**FIRST ADDENDUM TO THE SUPPLEMENTAL
ENVIRONMENTAL IMPACT REPORT FOR THE OAKLAND
ARMY BASE AUTOMALL PROJECT**

**FIRST ADDENDUM TO THE
SUPPLEMENTAL ENVIRONMENTAL IMPACT REPORT
FOR THE OAKLAND ARMY BASE AUTO MALL
PROJECT**

**ADDRESSING PROJECT CHANGES RELATED TO SITE LAYOUT AND
ADDITIONAL INFORMATION ON TRAFFIC AND WASTEWATER**

December 2007

Figure 6: Non-Port-Dependant Roadway Alignment Option

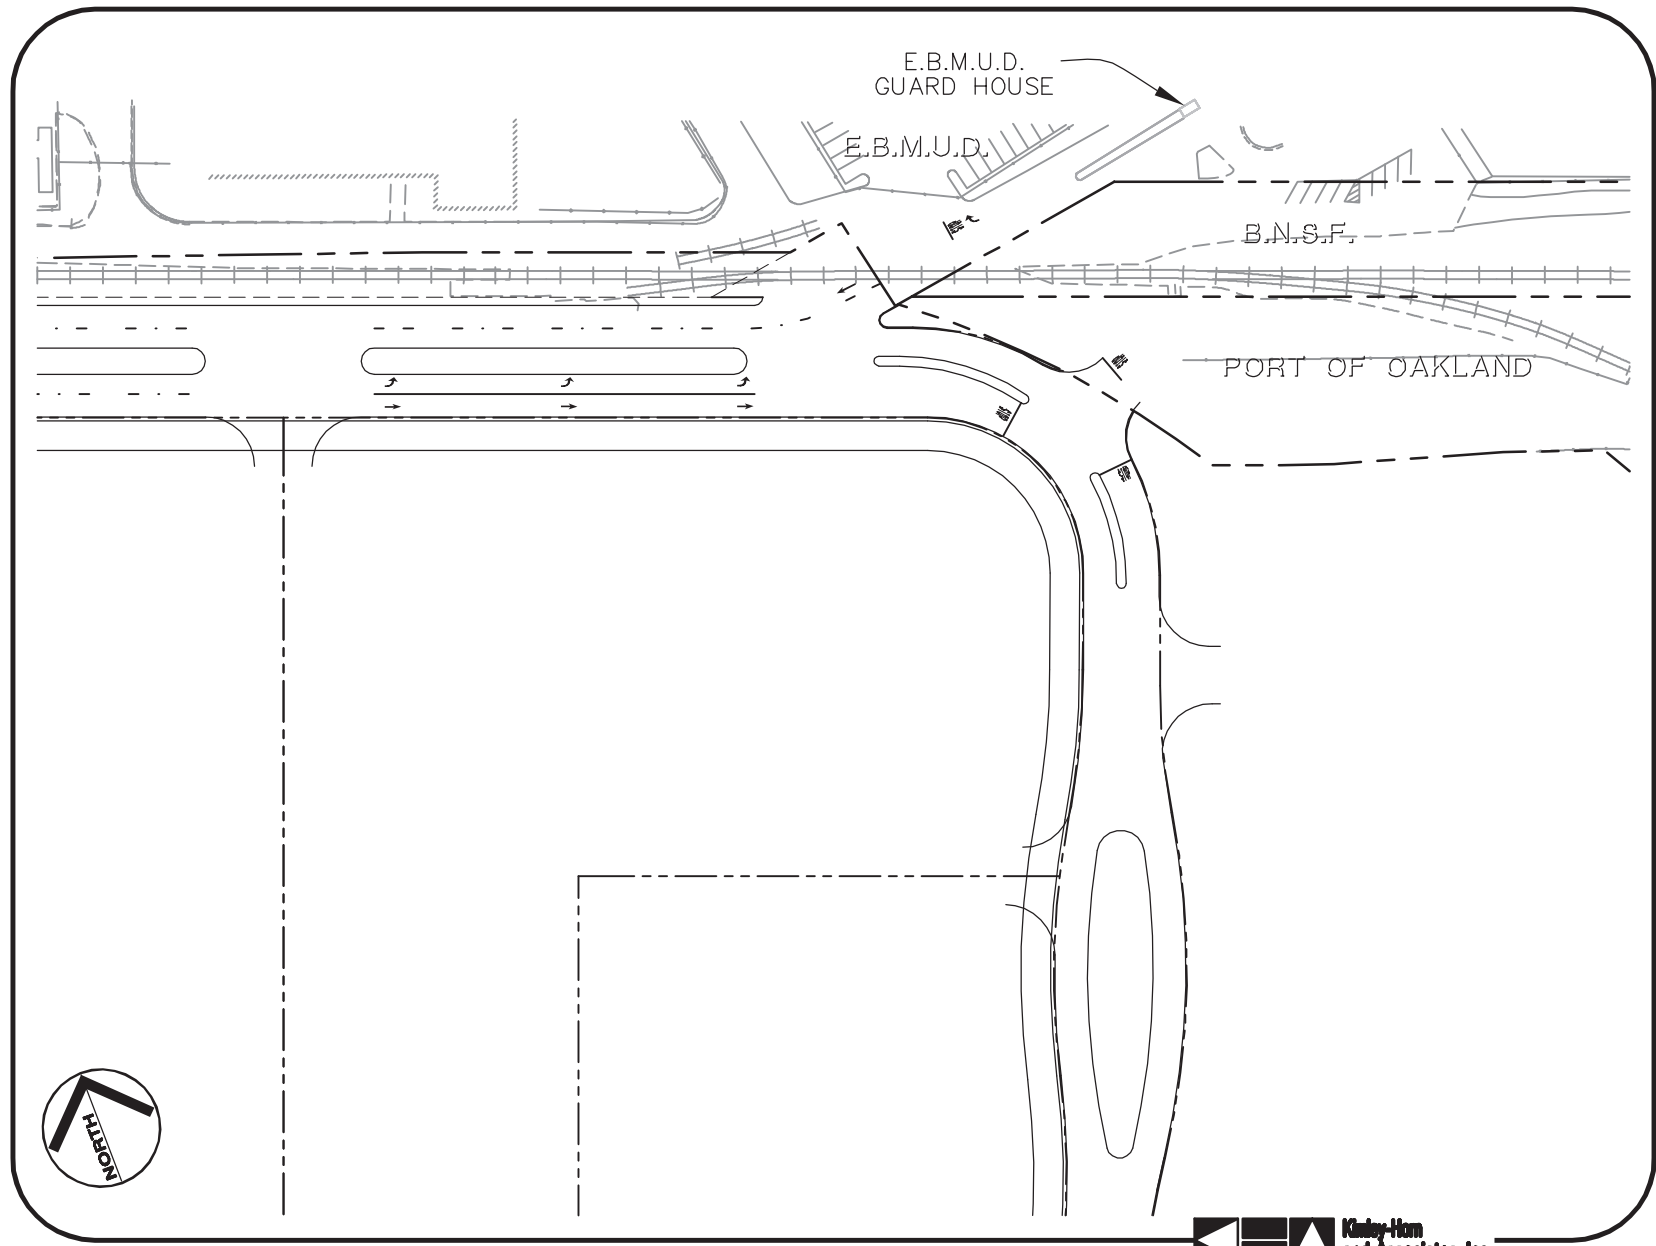
The Non-Port-Dependant Roadway Alignment option (Figure 6 on p.13) represents a slight change in the alignment of the North Access Road to avoid a small Port-owned parcel of land. While negotiations are underway to allow for construction on this parcel (likely involving a land swap between the City and the Port), this roadway alignment option would be considered in the event negotiations fall through or cannot be finalized in the timeline of the Auto Mall project. This alternative alignment of the North Access Road is an option independent from the EBMUD access options shown in Figures 4 and 5, and does not preclude either of these options. The Non-Port-Dependant Roadway Alignment option is described as follows:

The Non-Port-Dependent Roadway Alignment could be combined with either of the EBMUD access options and would not change any of the analysis or conclusions in this document. The capacity of the North Access Road and East Access Road intersection would be reduced slightly by combining the two eastbound lanes into one, but the remaining capacity would be adequate. The intersection would serve fewer than 300 total through vehicles on the main roadway and fewer than 10 vehicles at the driveway and would operate at LOS A during the peak hours of operation.

Figure 7: Wake Avenue and 34th Street Easement

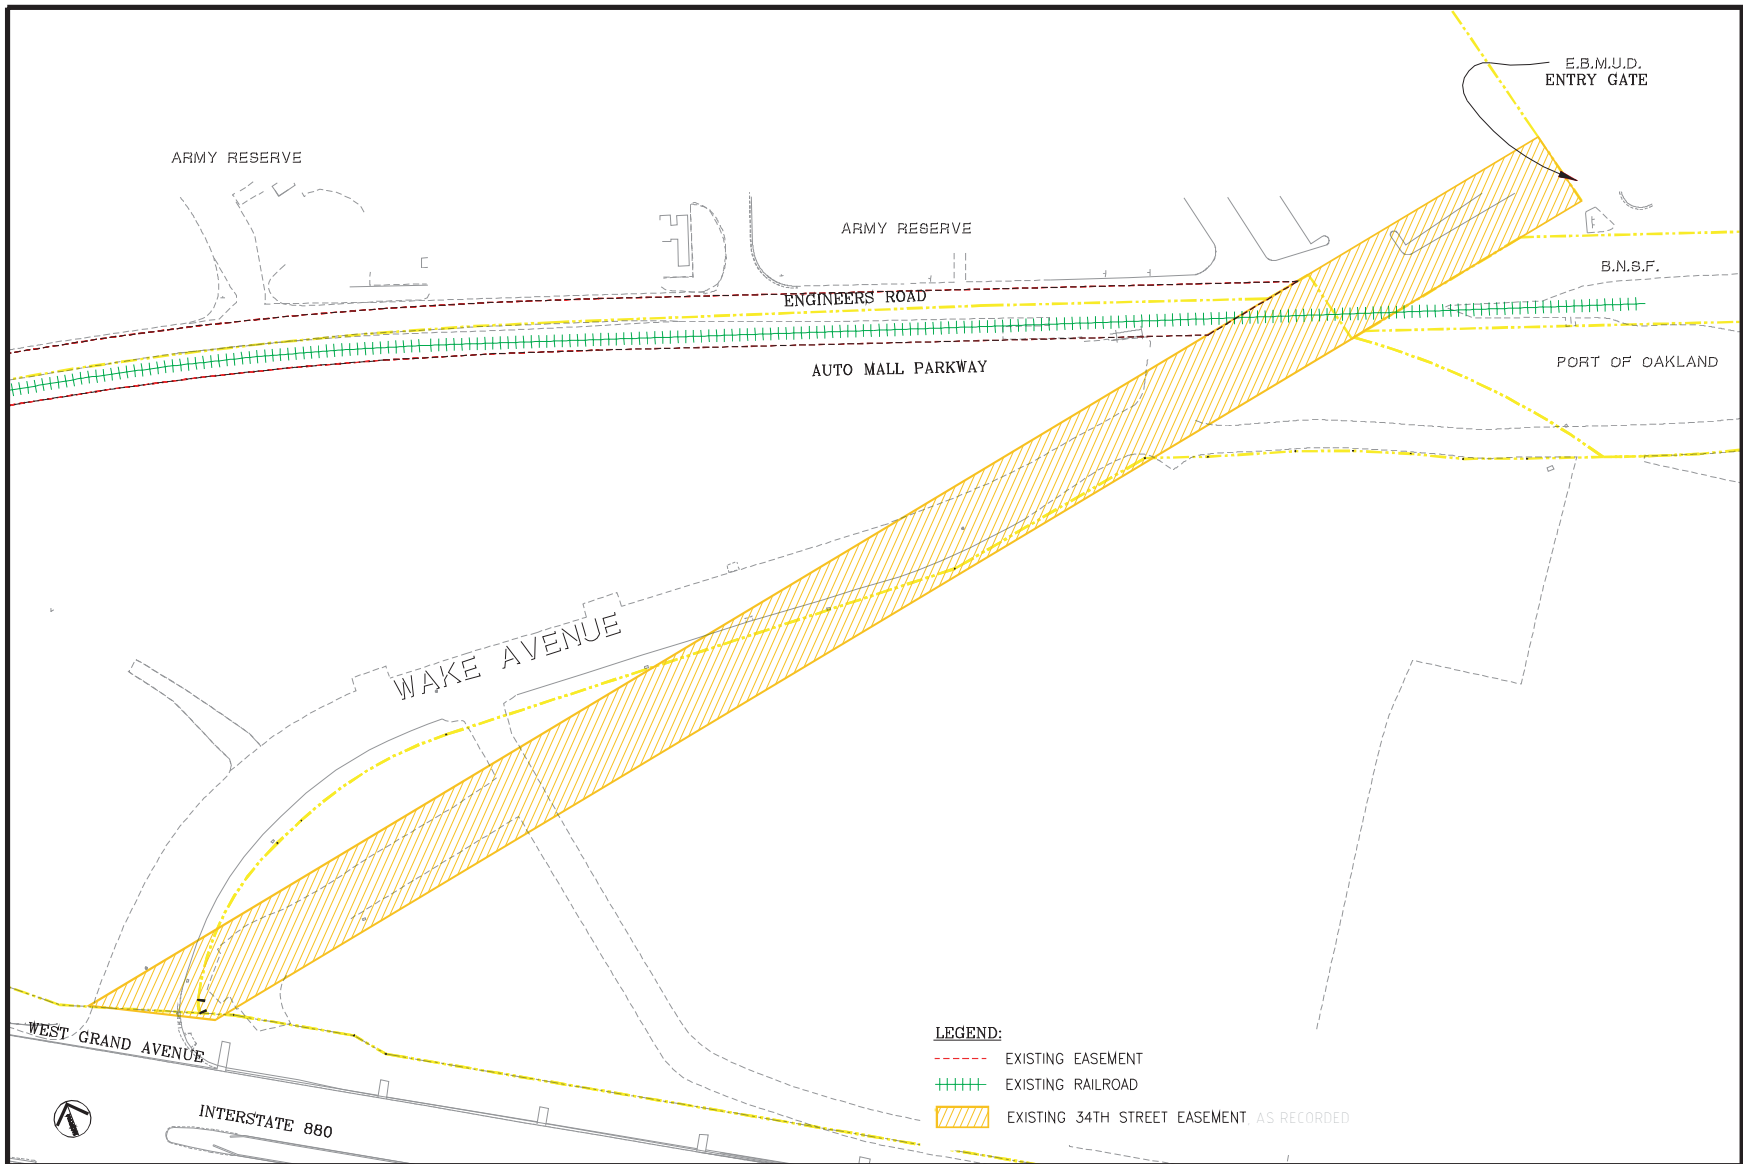
Additionally, the current ownership status of Wake Avenue has been clarified. Wake Avenue had been discussed in the Final SEIR as a private road, yet portions of this private road (particularly where it crosses the railroad tracks) overlap with public right-of-way. A portion of Wake Avenue aligns with the 34th Street public right-of-way at the railroad crossing just south of EBMUD main entrance, as shown in **Figure 7**. However, the entirety of Wake Avenue is a more circuitous route that does not wholly align with the public right-of-way nor does it meet city standards for public streets. Clarification of the issue of ownership does not change any impacts identified under the OARB Auto Mall SEIR, or the mitigation which specifies that the final design of the roadway and intersection with EBMUD access must provide adequate levels of safety, meet city standards, and that reasonable access to the EBMUD facilities must be maintained at all times. A separate process for street vacation of all or part of the 34th Street Easement (and thereby Wake Avenue) will need to be undertaken by the City, pursuant to the Streets and Highways Code.
